**ZONING BOARD OF APPEALS APPLICATION FOR PUBLIC HEARING (VARIANCES, SPECIAL EXCEPTIONS, APPEALS OF ADMINISTRATIVE DECISIONS)**

Address: 828 S Stone Mountain Lithonia Rd City: Lithonia State: GA Zip: 30088

# Plan Review - Workflow Routing Slip

# Plan Review - Review Details

1 WALL TYPE '1' SCALE: 3"=1'-0" 2 WALL TYPE '2' SCALE: 3"=1'-0" 3 WALL TYPE '3' SCALE: 3"=1'-0" 4 WATER CALCULATION SCALE: 3"=1'-0"

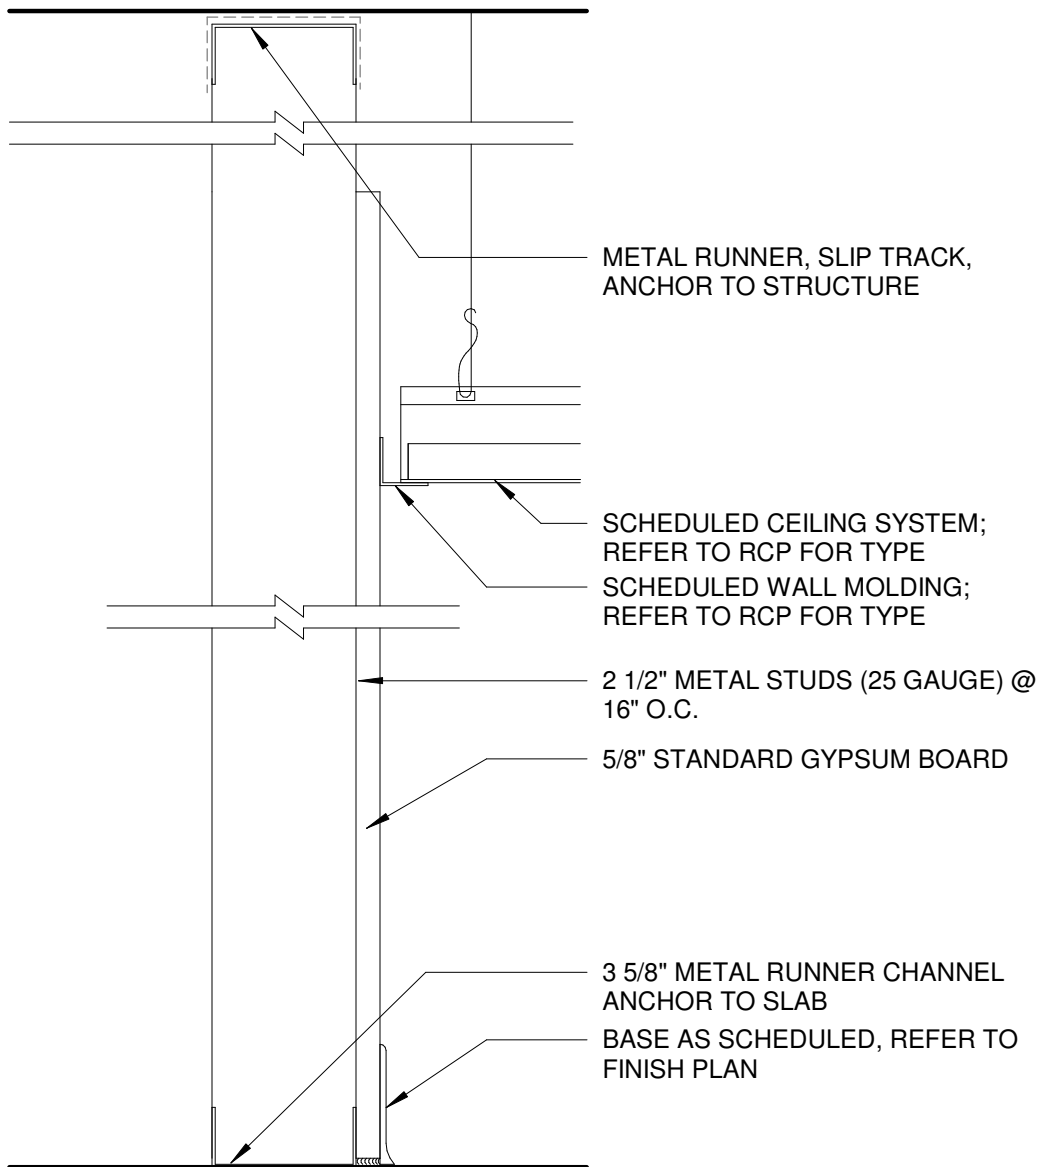
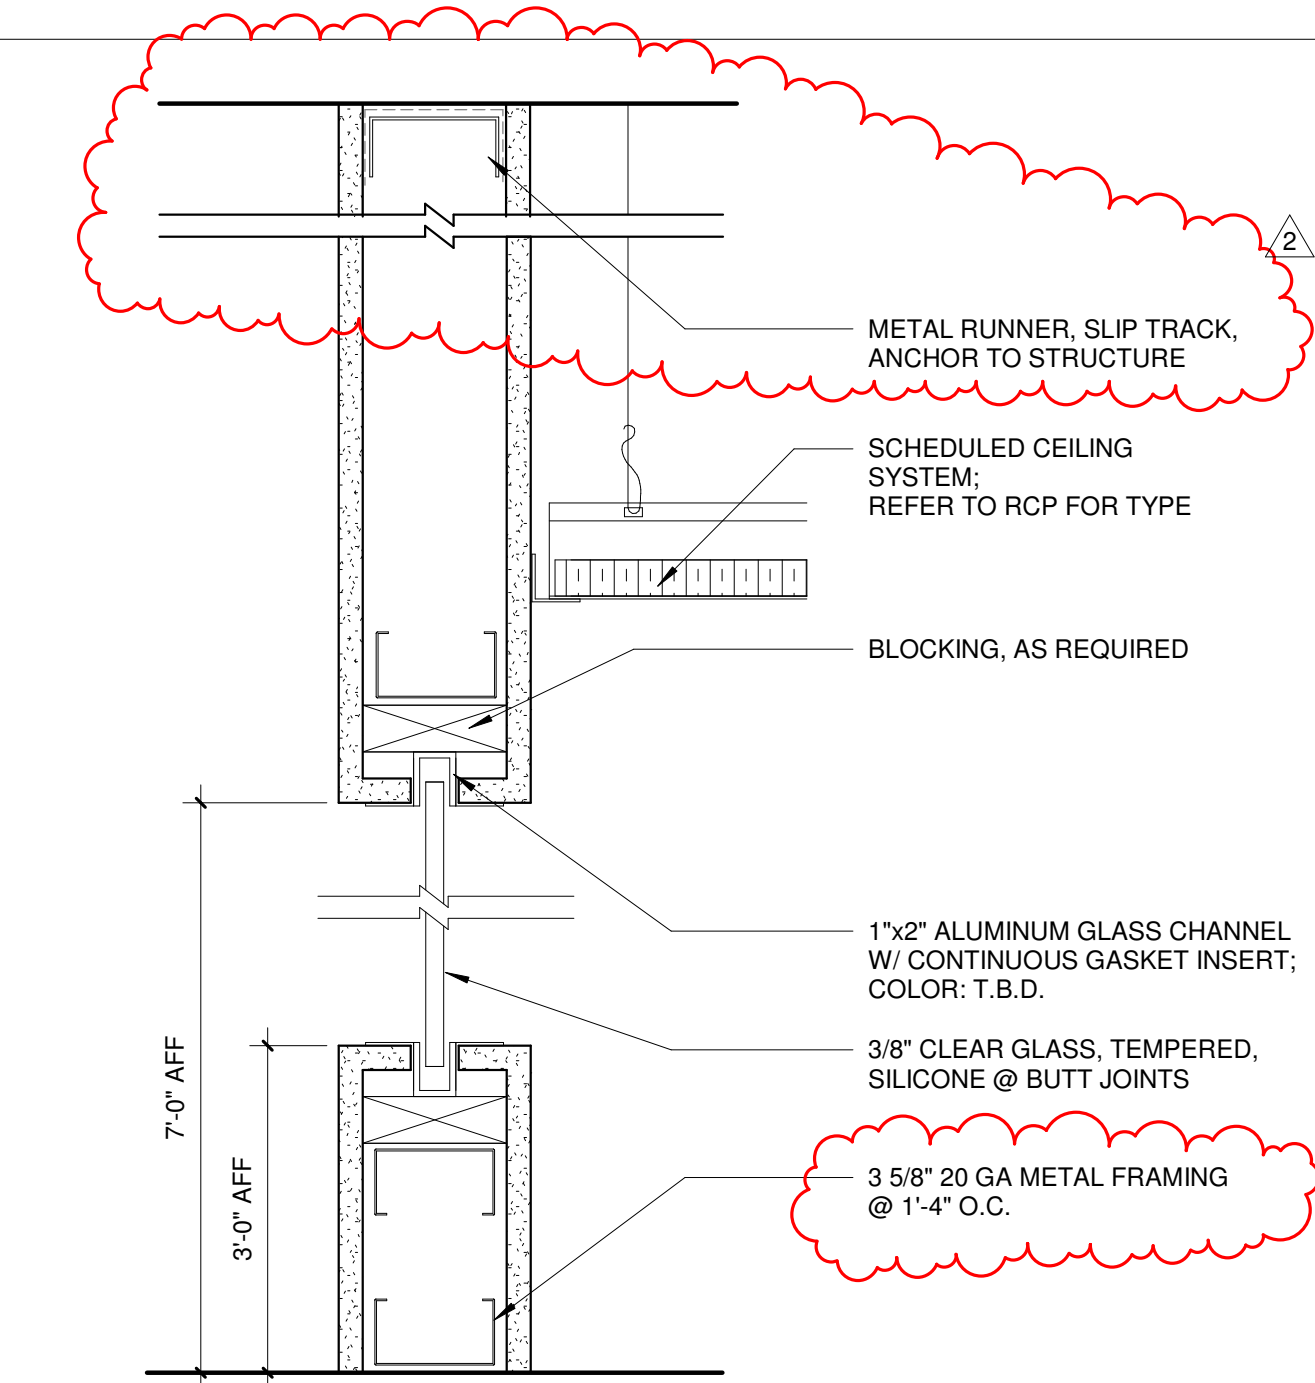
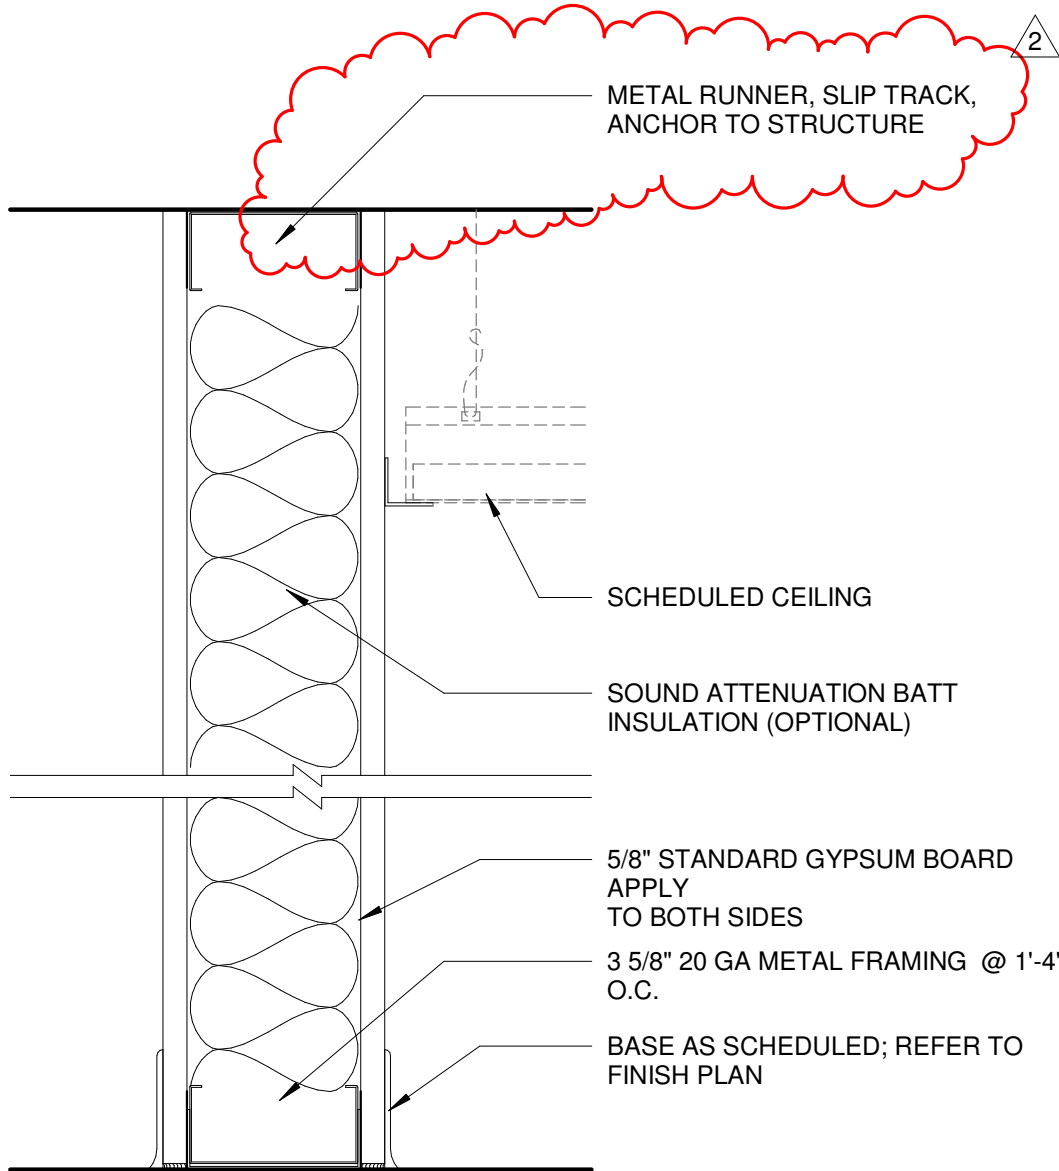
REF #	CYCLE	REVIEWED BY	TYPE	FILENAME	DISCUSSION	STATUS
23	1	COMMERCIAL STRUCTURAL PLANS Tony Pruitt 11/15/23 12:40 PM	Changemark HEAD OF WALL DOES THIS WALL "TYPE 2" EXTENDS TO AND ANCHORED TO THE STUCTURE ABOVE? IF SO, PLEASE SHOW DETAIL FOR DEFLECTION, GAUGE & SPACING OF METAL STUDS. (TYP.)	A7 Wall Types and Misc Details.pdf	Responded by: Christopher TzegaegbE - 6/25/24 11:00 AM Revision submitted  ----- Responded by: Christopher TzegaegbE - 4/16/24 11:15 AM Revision made on latest submitted version V3  ----- Responded by: Christopher TzegaegbE - 3/13/24 8:58 AM Revisions made	Resolved
24	1	FATS OILS GREASE REVIEW Yola Lewis 11/27/23 10:25 PM	Changemark WS Changemark note #01 Provide a plumbing plan for the sewer line. it must show the grease trap and all req fresh air fixtires connected to iti. mop sink included.	P1 Plumbing Plans.pdf	Responded by: Christopher TzegaegbE - 4/16/24 11:16 AM Revision made on latest submitted version V3  ----- Responded by: Christopher TzegaegbE - 3/13/24 8:58 AM Revisions made	Resolved

6 CANOPY DETAIL SCALE: 3/4"=1'-0" 7 ENTRANCE CANOPY DETAIL SCALE: 3/4"=1'-0" 8 ADA DOOR CLEARANCES

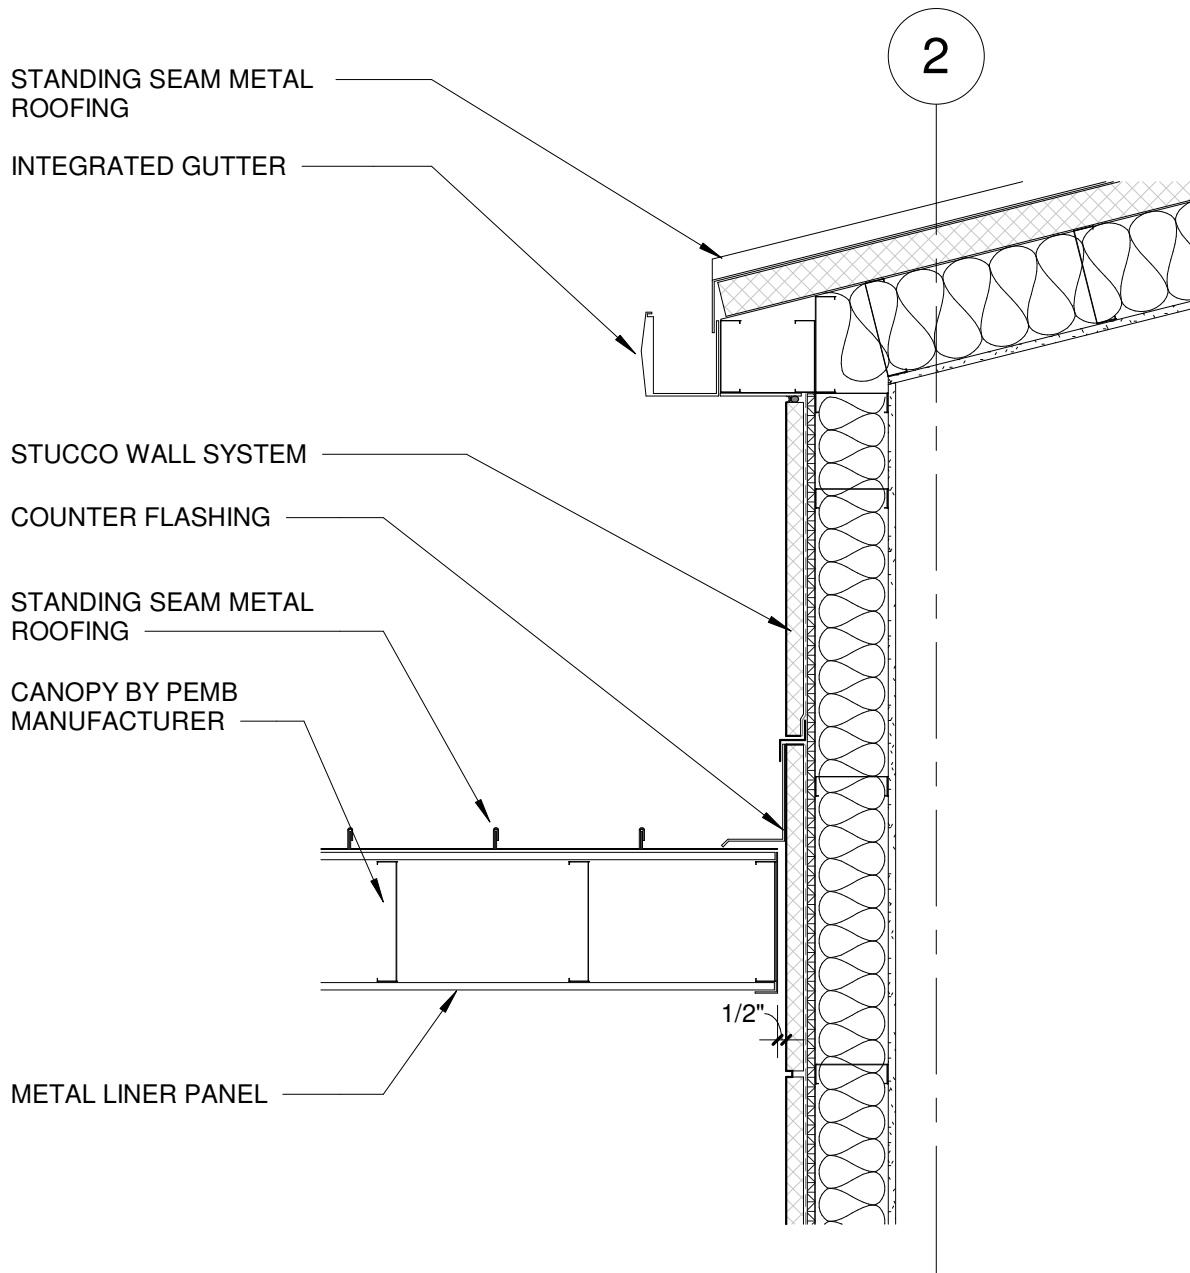
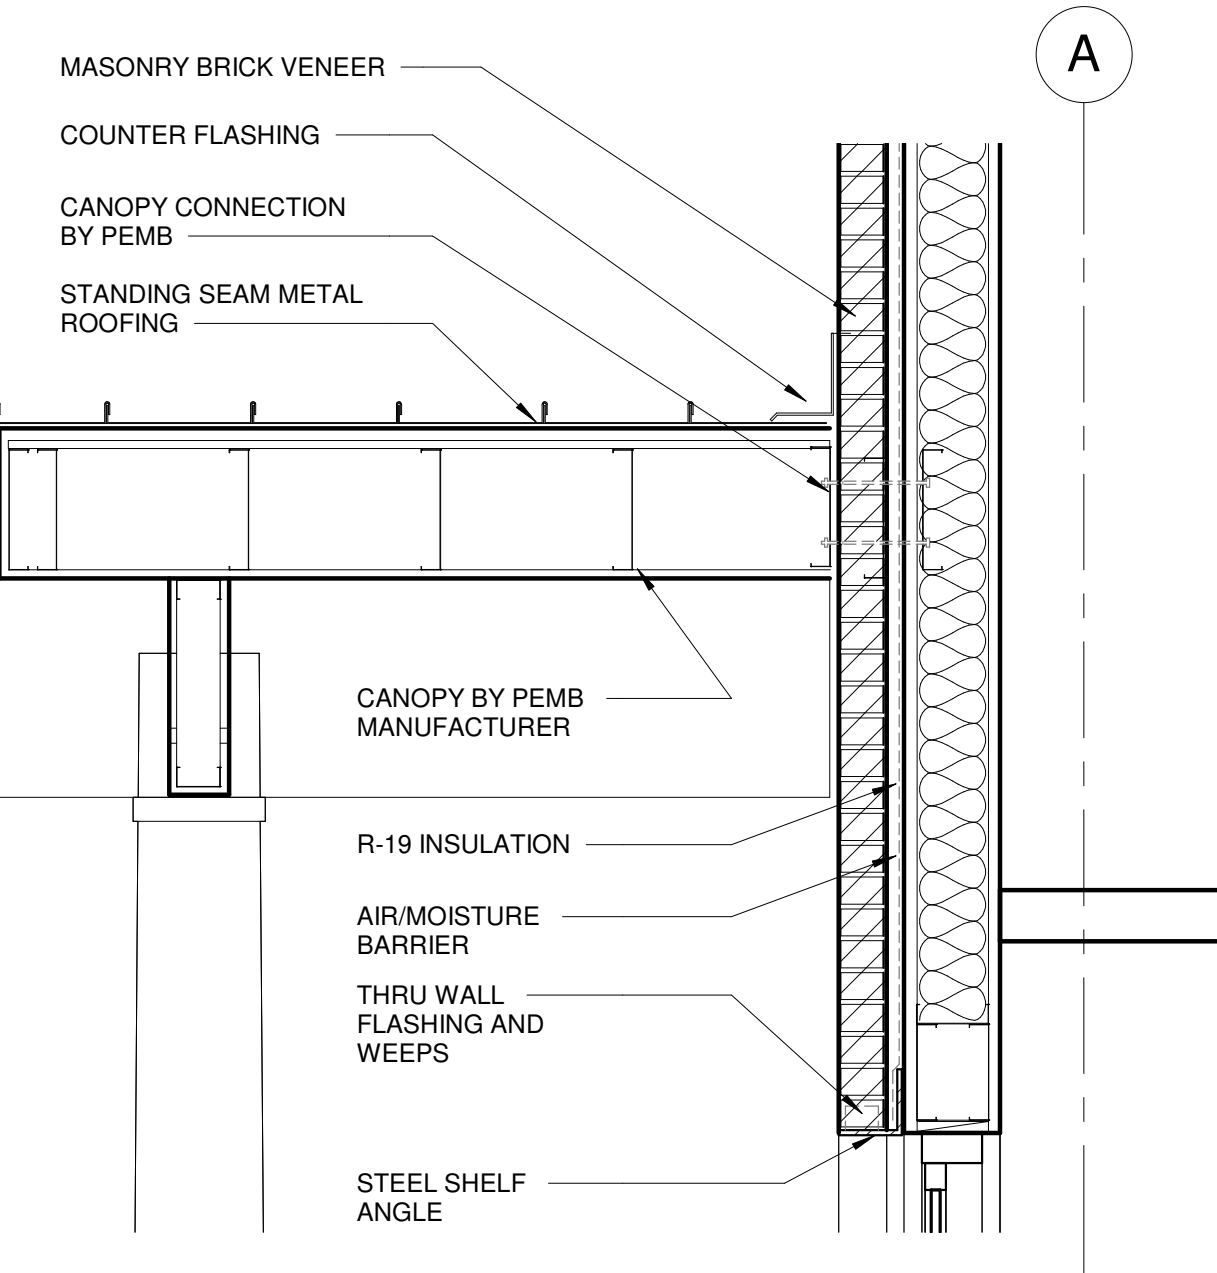
22	1	COMMERCIAL STRUCTURAL PLANS Tony Pruitt 11/15/23 12:26 PM	Changemark WALL/CANOPY DETAILS PLEASE SHOW WITH DETAILS HOW THE CANOPIES INTERACT WITH THE WALL STRUCTURE.	A5 Building Elevations.pdf	Responded by: Christopher TzegaegbE - 3/13/24 8:58 AM Revisions made	Info Only
